# Product/process change notification

PCN N° 2021-132-A

### Introduction of BEOL process loop needed for products with Gen5/5.2 gate drivers

Introduction of BEOL process loop needed  
for products with Gen5/5.2 gate drivers  
Customer information package for  
PCN 2021-132-A

## Change overview and scope of change

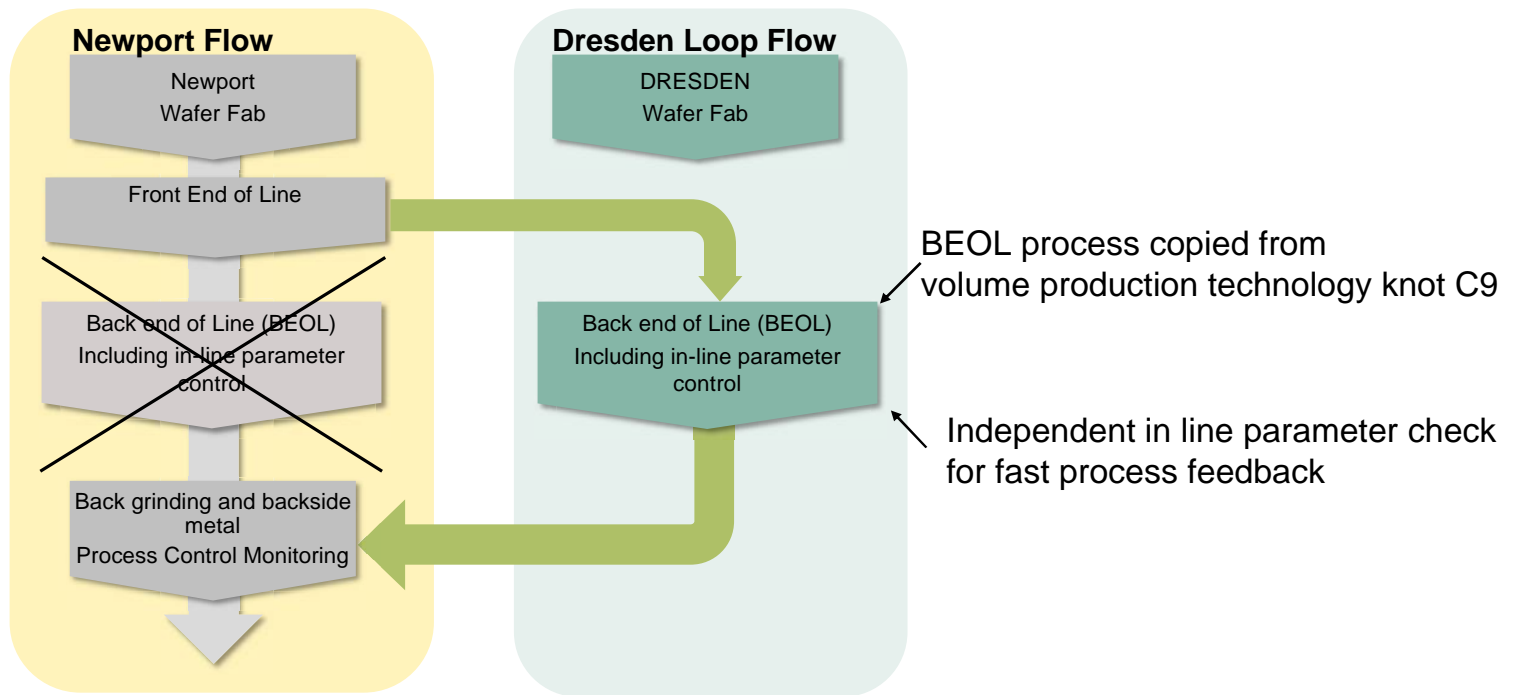
Description	Old	New
Backend of Line (BEOL) process	Wafer Fab Ltd. (NWF Ltd.) Newport, United Kingdom	Infineon Technologies Dresden GmbH, Dresden, Germany

- › **No change in all other process steps, in particular wafer test, assembly and final test**

## Main points of interest for technology & product qualification

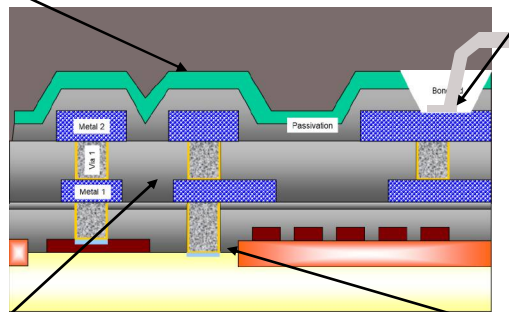
› With the new BEOL process several material interface are to be assessed.

Area of interest is the interface of the passivation and bond pad opening to the mold compound.

Area of interest is the interface of the bonded wire and the pad metal.

Area of interest is the interface performance of the BEOL metal stack.

Area of interest is the interface of the BEOL layers to the layers below.
